ENGINEERING CHANGE NOTICE

1. ECN 186756

5. Project Title/No./Work Order No. 300-FF-5 RI/FS		6. Bldg./Sys./Fac. No.		7. Impact Level 4
8. Document Number Affected (include rev. and sheet no.) DOE/RL 89-14 rev. 0		9. Related ECN No(s).		10. Related PO No.
11a. Modification Work <input type="checkbox"/> Yes (fill out Blk. 11b) <input checked="" type="checkbox"/> No (NA Blks. 11b, 11c, 11d)	11b. Work Package Doc. No. NA	11c. Complete Installation Work NA _____ Cog. Engineer Signature & Date	11d. Complete Restoration (Temp. ECN only) NA _____ Cog. Engineer Signature & Date

12. Description of Change Attached is a complete copy of all 300-FF-5 Work Plan changes as of September 24, 1992. Included in this ECN are Change Control Forms 300-FF-5-01, 300-FF-5-02, 300-FF-5-04, 300-FF-5-05, 300-FF-5-06, 300-FF-5-07, 300-FF-5-08, 300-FF-5-10, 300-FF-5-11, 300-FF-5-12, 300-FF-5-13, 300-FF-5-14, 300-FF-5-15, 300-FF-5-17, 300-FF-5-19, 300-FF-5-20, and 300-FF-5-21. Also included is a change control log which identifies where discussions of the individual change forms can be found. Future work plan changes will be made on individual ECN's.				
13a. Justification (mark one)		Criteria Change <input ch

WELL CONSTRUCTION AND COMPLETION SUMMARY

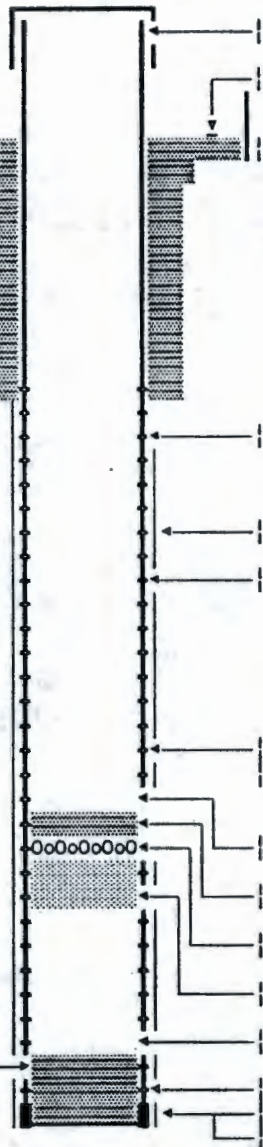
Impacts to groundwater quality should not occur with only 11.5 ft of surface seal. As presented on the Well Construction and Completion Summary the first perforations are at 18 ft. Contaminants would have a significant distance to travel before they could enter the well. Additionally, the amount of material placed to shorten the monitoring interval should inhibit the movement of contaminants to deeper sections within the aquifer.

REMEDICATION:
 Dec91~Jan92, by WHC/KEH
 Overdrilled 8-in casing with 15-in hollow-stem auger rig. Grouted annulus with cement. Cement entered borehole through upper existing perforations. Excavated and installed concrete surface pad, posts and survey marker. Extended casing 0.79-ft to 3.0-ft stickup.

WELL CONSTRUCTION AND COMPLETION SUMMARY

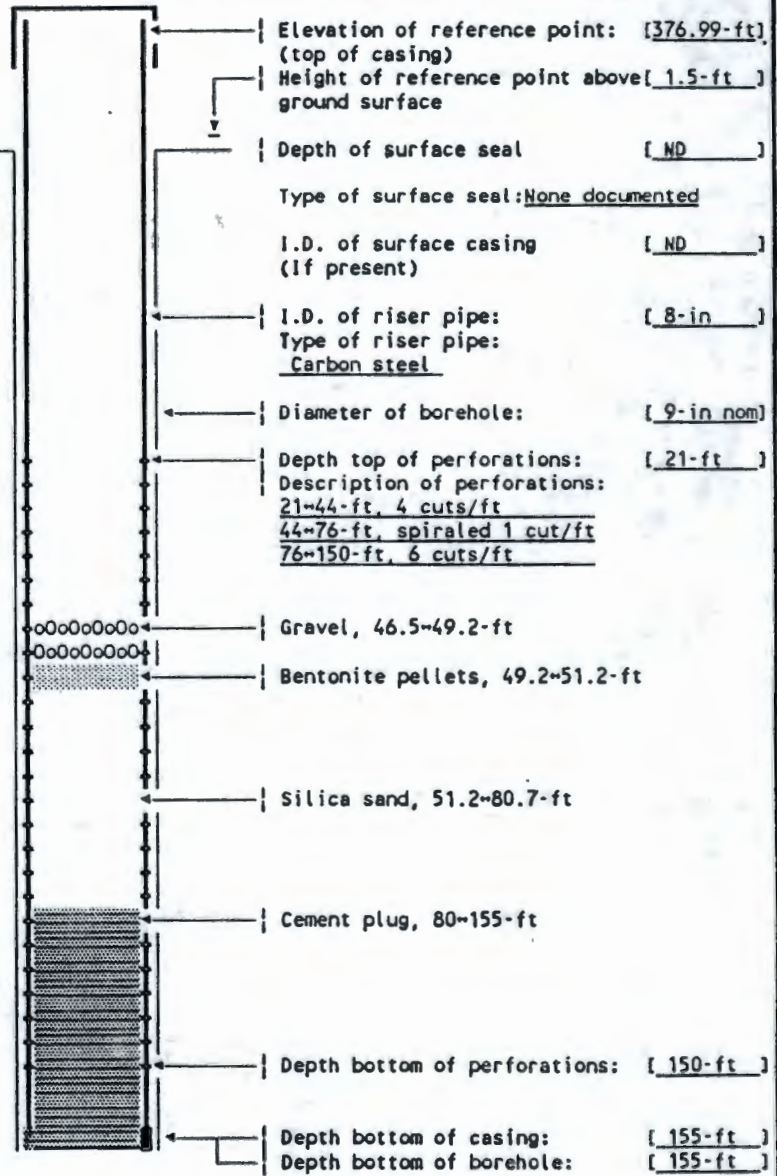
Well 399-4-7:

Well perforations extend from 21 to 150 ft. The interval was shortened in June of 1987 by placing a wooden and cement plug from 155 to 80 ft. In July of 1991, the interval was shortened again from 80.7 to 51.2 ft using silica sand. Bentonite pellets were added from 51.2 to 49.2 ft and gravel was placed from 49.2 to 46.5 ft.

A surface seal will be installed in early 1992 by overdrilling the casing with an auger to 18 ft. Bentonite will be added from 18 to 16 ft and cement grout then pumped to the surface. This will result in a 16 to 17 ft surface seal.

Figure 43. River Sampling Layout Associated with Riverbank Spring Locations.

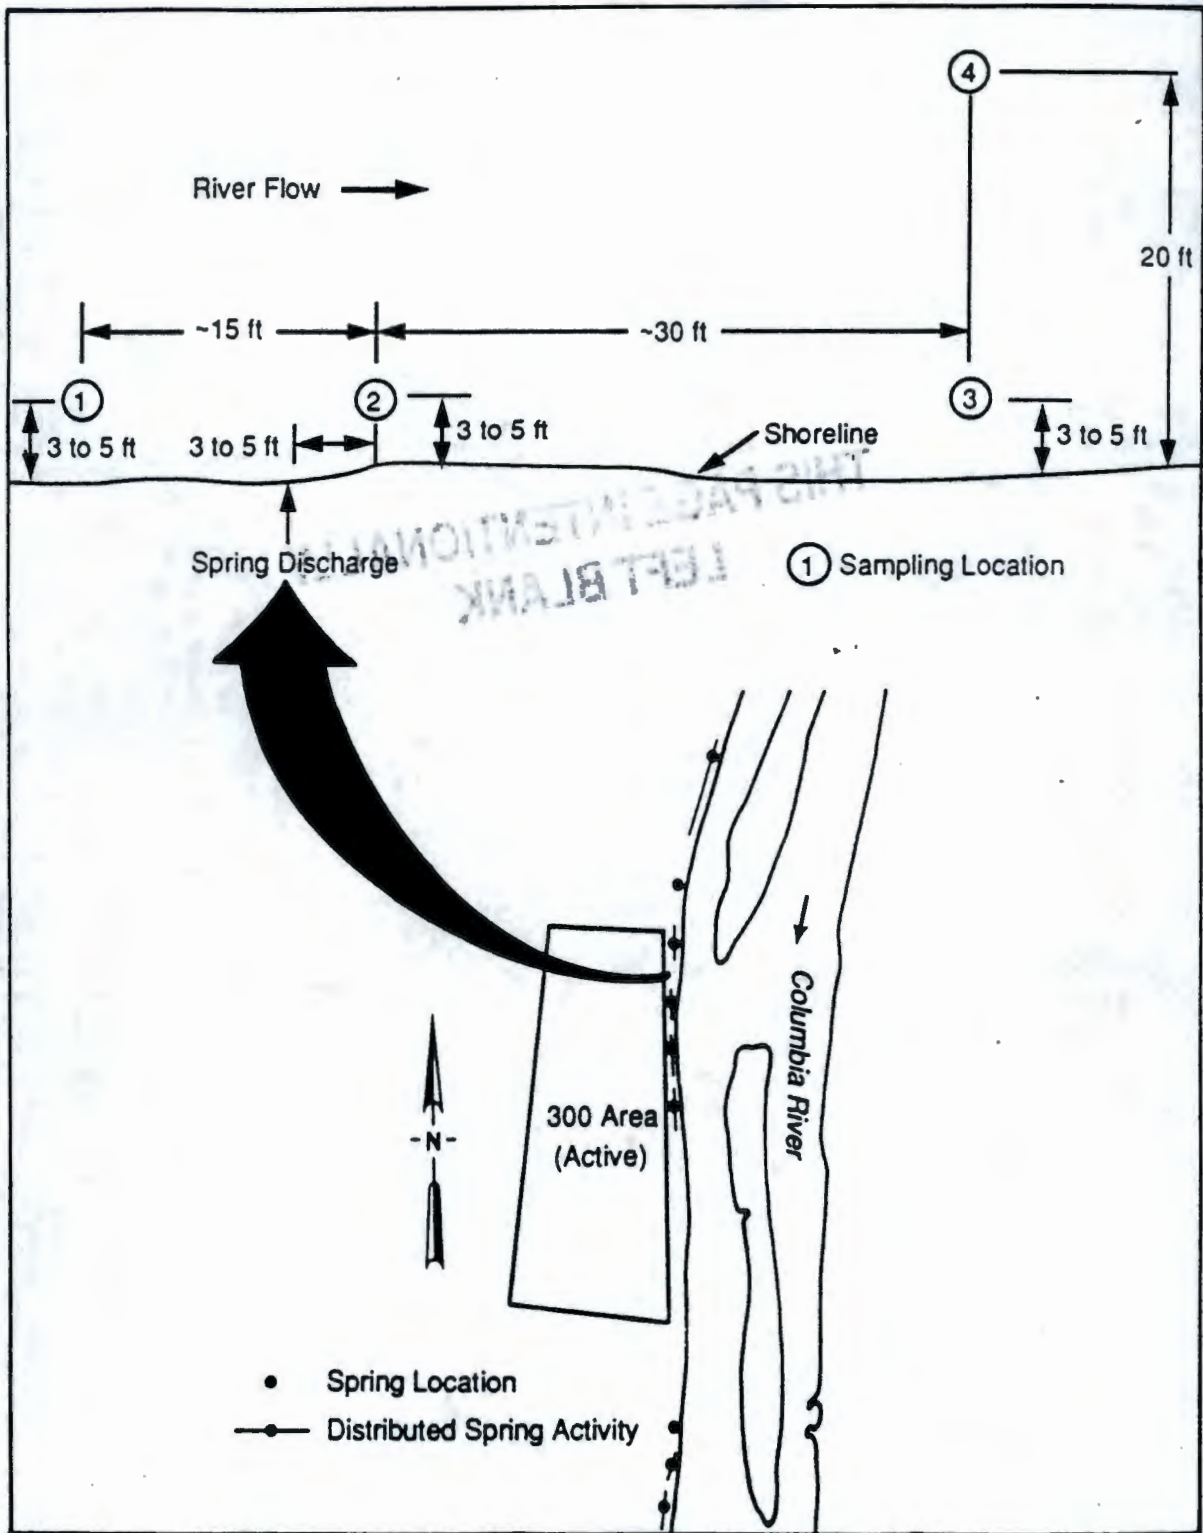
In Task 5C, Near Shore River Water and Sediment, described in Section 5.3.5.3 of the work plan a sampling scheme is described. This is shown as Figure 43 in the work plan. As a result of a meeting held on September 17, 1992 with the regulators it was agreed that sampling of the river would be modified. Figure 1 from the FSP (WHC-SD-EN-AP-107) for this activity is also attached and identifies the 4 major spring locations that were sampled in conjunction with the river sampling. Upriver from spring site 6 a transect sampling at about 3 ft, 10 ft, and 20 ft from shoreline would be performed. Samples would be taken at mid river depth from each location. Immediately below spring site 9 a similar transect sampling would be performed. Downstream from spring site 11 a third and final transect sampling would be performed. Instead of 4 samples at all spring locations only 3 samples at 3 locations would be taken.

Note: Include affected page number Section 5.3.5.3 (WP-181-184), Figure 43 (WP-182), Section 2.2 (SAP/FSP-23), Table 6 (SAP/FSP-24), Figure 5 (SAP/FSP-26)
